| SERVICE LETTER NUMBER 157 | | | |
| TITLE: 10000 BULKHEADS 9-12, LOWER FLANGE REINFORCEMENT | | | |
| BY: M.DILLON | AIRCRAFT MAKE/MODEL(S): AIR TRACTOR AT-802, AT-802A | FLOAT MODEL(S): 10000 | NOTE(S): OPTIONAL COMPLIANCE S/L P/N 1008067 ECO - 23622 |

FIGURE 1: AFFECTED BULKHEAD FLOAT STATION LOCATIONS

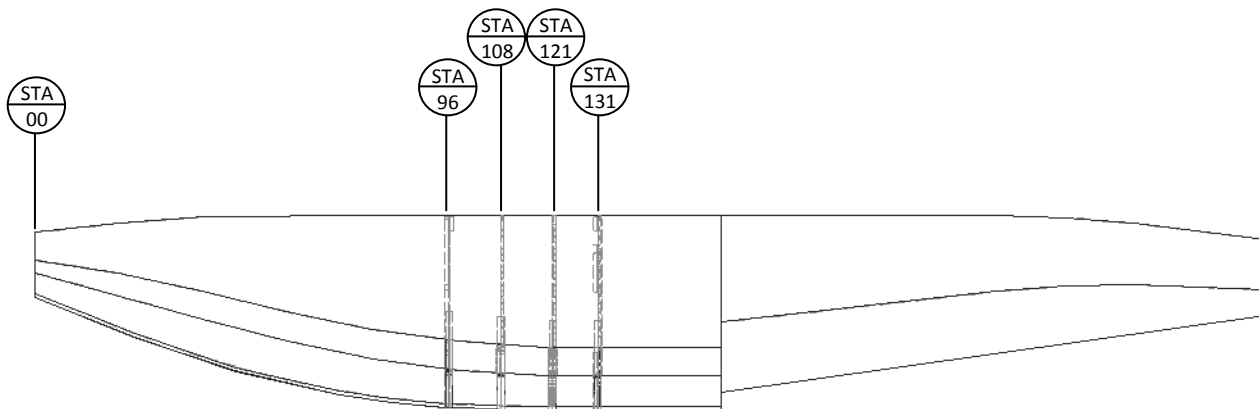
Aircraft equipped with Wipline model 10000 amphibian floats and regularly operated in rough water may experience cracking of the forward and aft lower bulkhead flanges located in the baggage area of the float as indicated in Figure 1. This service letter and associated kit reinforce the lower bulkhead flanges to reduce probability of cracking as a result of operations in rough water.

- 1) Remove the top deck covers and open baggage hatches to gain access to the affected bulkheads shown in Figure 1. Remove baggage hatch floors to gain access to lower bulkhead flanges.
- 2) If cracks are found in flanges, stop drill as needed.
- 3) After drilling interfering rivets out of existing bulkhead, position the doublers best fit to contour and match drill at each forward and aft lower bulkhead flange.
 - 1 Match drill these rows to existing rivet locations in lower flange and bulkhead face.
 - 2 Add this upper row at 0.5 inch edge distance using the forward doubler, and then match drill into the aft doubler. Match lower row spacing.

FIGURE 2: BULKHEAD 10A01000-418 AT FLOAT STA 96

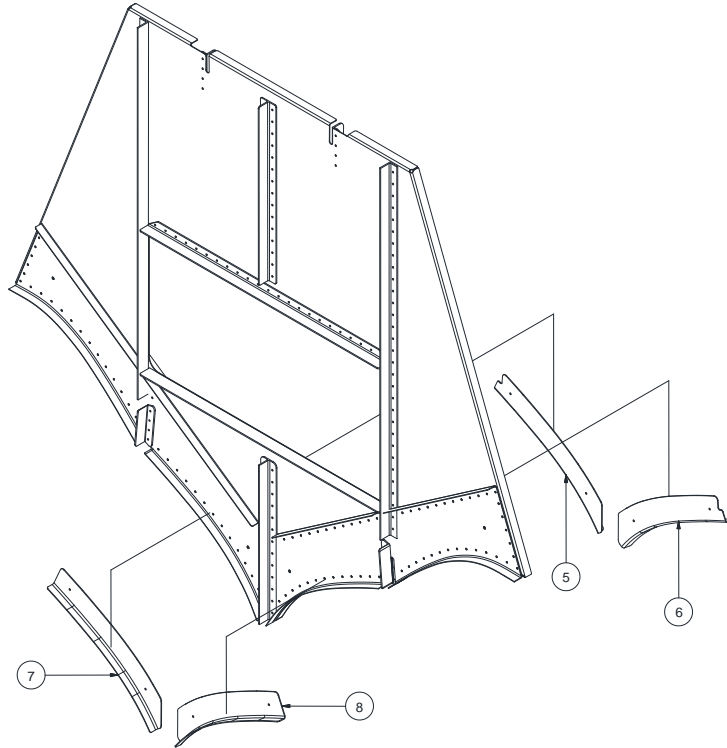
- 4) Deburr all drilled rivet holes in bulkheads and doublers.
- 5) One doubler at a time; apply PR1422 sealant completely to mating faces of doubler, bulkhead, and bottom skin, then rivet appropriate doublers as called out in the Parts List and Figures 2-5 to the forward and aft lower bulkhead flanges and bottom skin using MS20470AD4 rivets, grip as required. Perform this operation at bow bulkheads indicated in Figure 1. Drive rivets while sealant is wet.
- 6) Wipe away excess wet sealant after riveting.
- 7) Replace baggage hatch floors and reinstall top deck covers with new seals.
- 8) Water check floats
